FOI reference: 21-097

## LETTER OF DESIGN REVIEW

Developer: Hindmarsh Constructions  
 Address: 81 Constitution Avenue Campbell ACT 2617  
 Contact: [REDACTED]  
 Project Title: Campbell Section 19 Block 28 (Stage 2)  
 Consultant: Sellick Consultants P/L  
 Address: PO Box 5005 Braddon ACT 2612  
 Contact: [REDACTED]  
 TCCS Project Lead: Ruwan Abeysekera

DRAWING TITLE: PLAN - SITE  
 SCALE: 1:200 @ A1  
 DATE: 2018

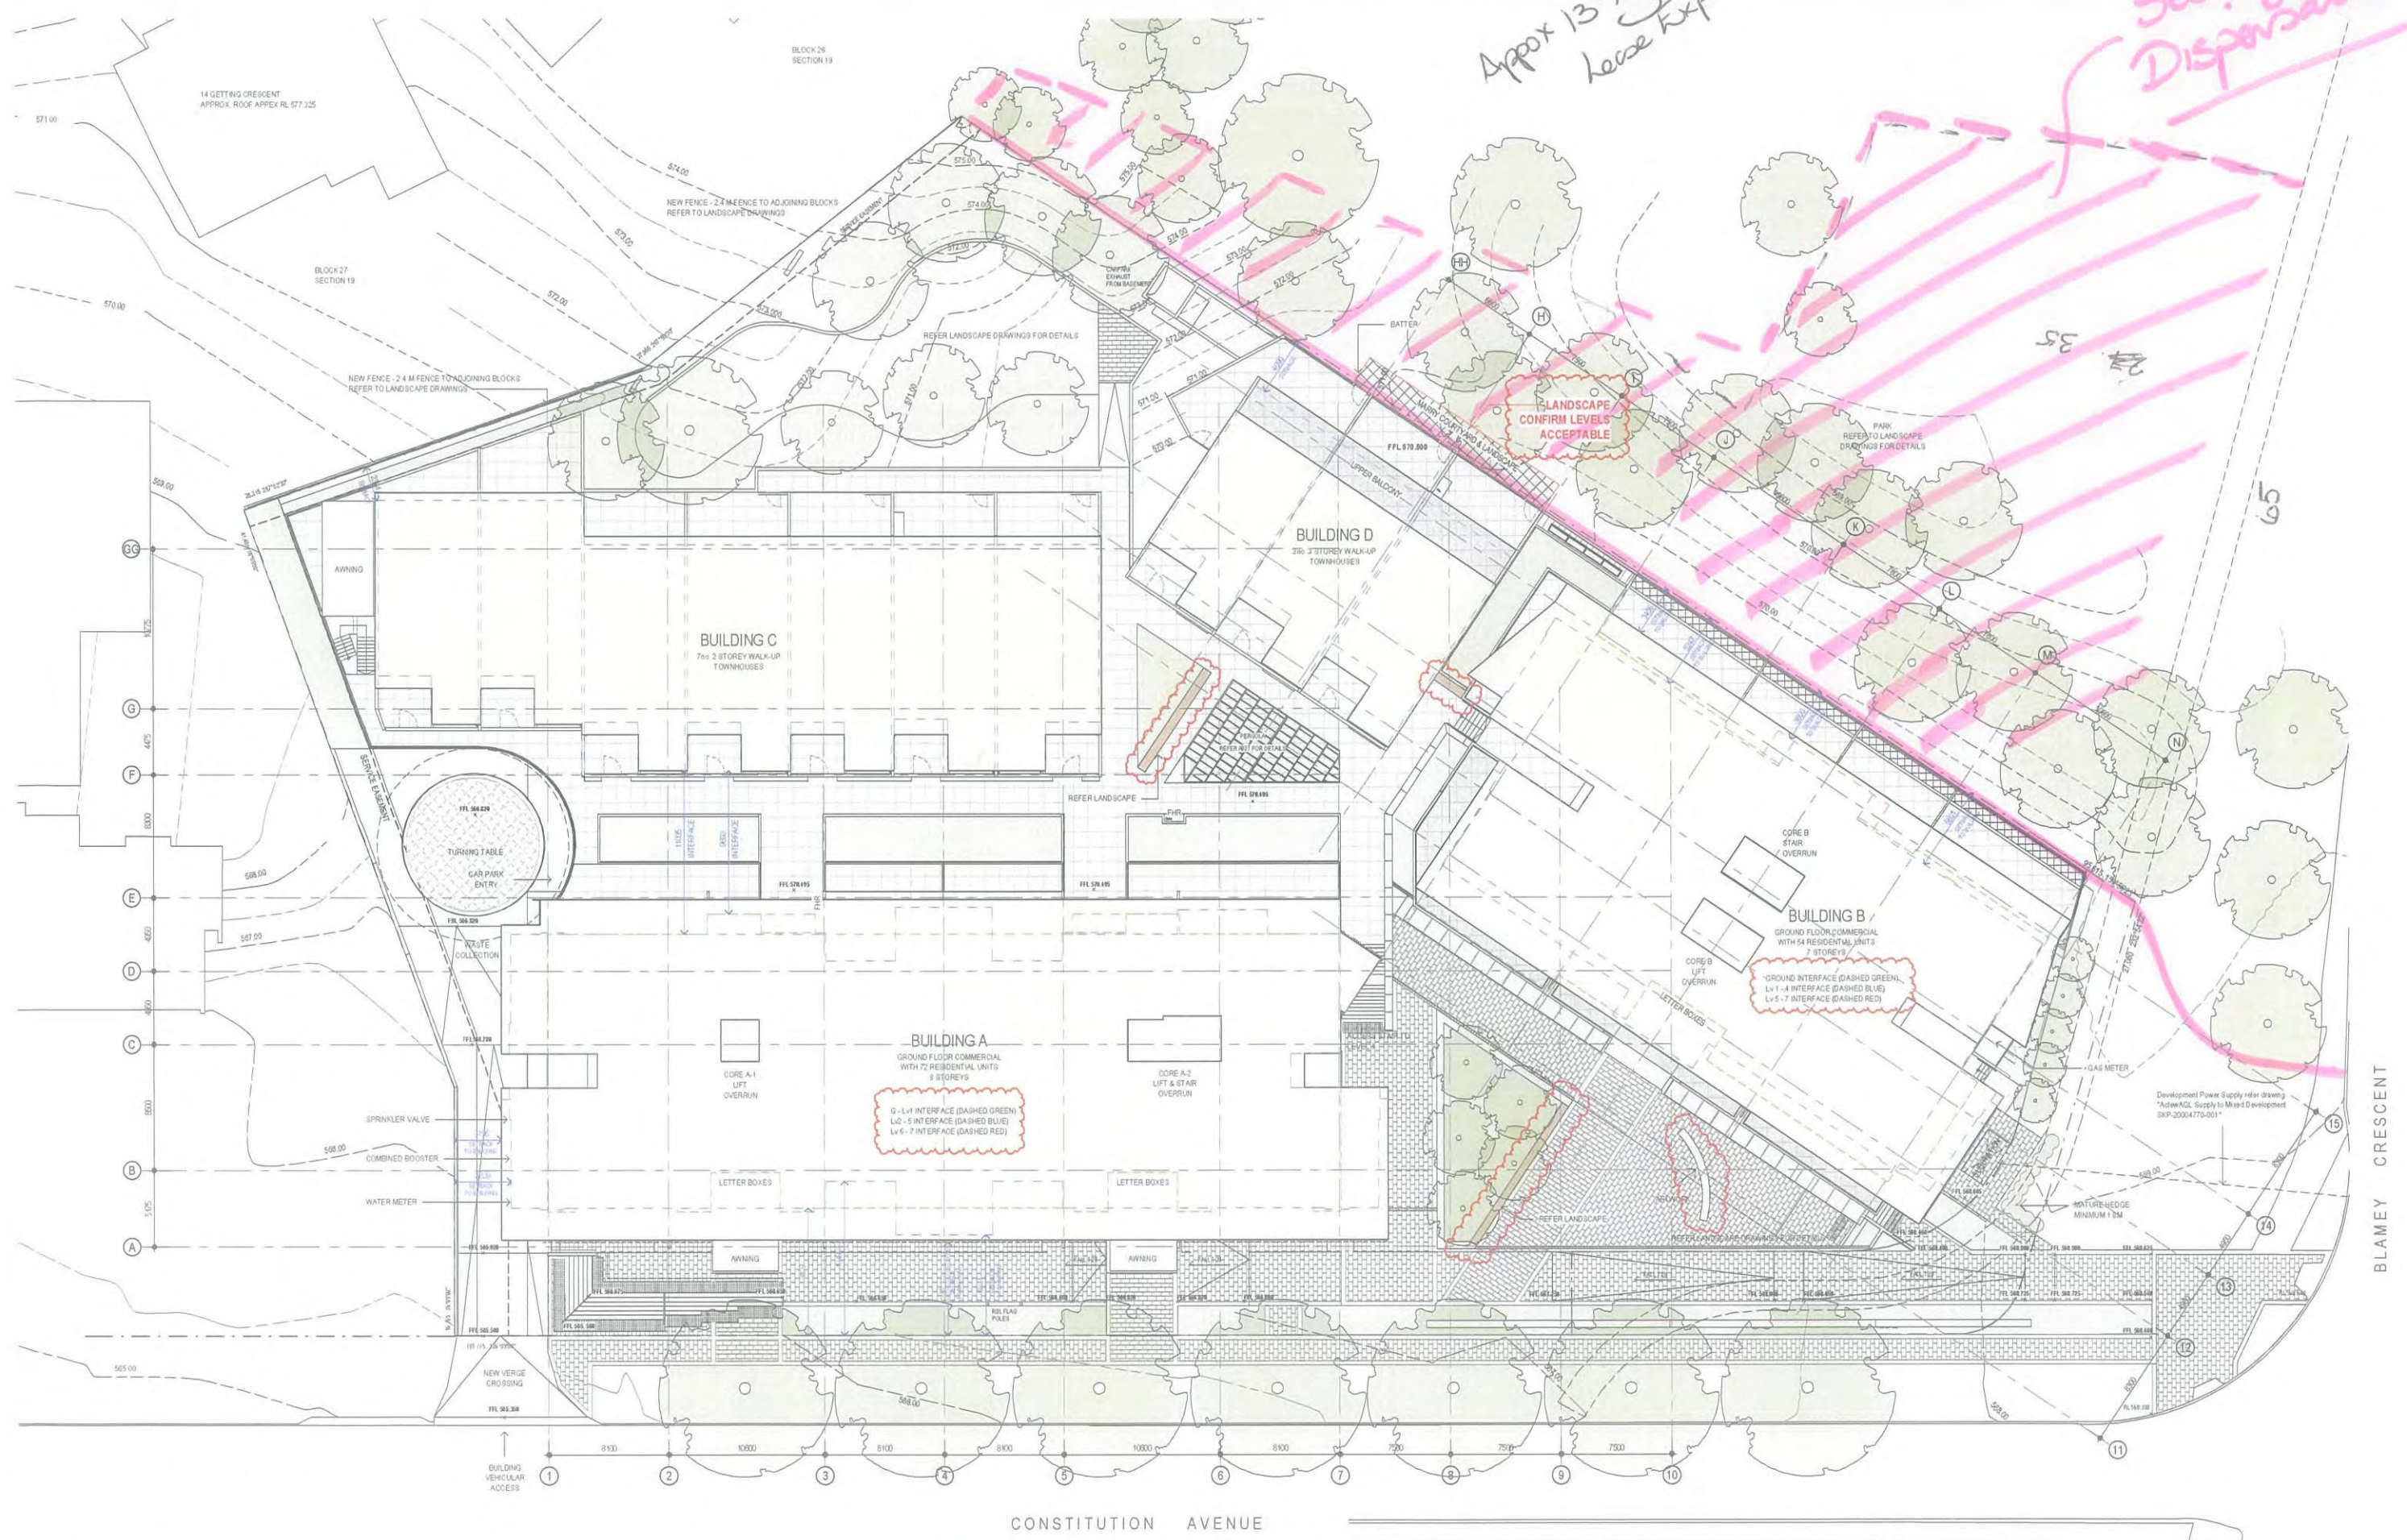
Approx 13<sup>th</sup> August  
Lease Expiry

Seeking  
Dispensation
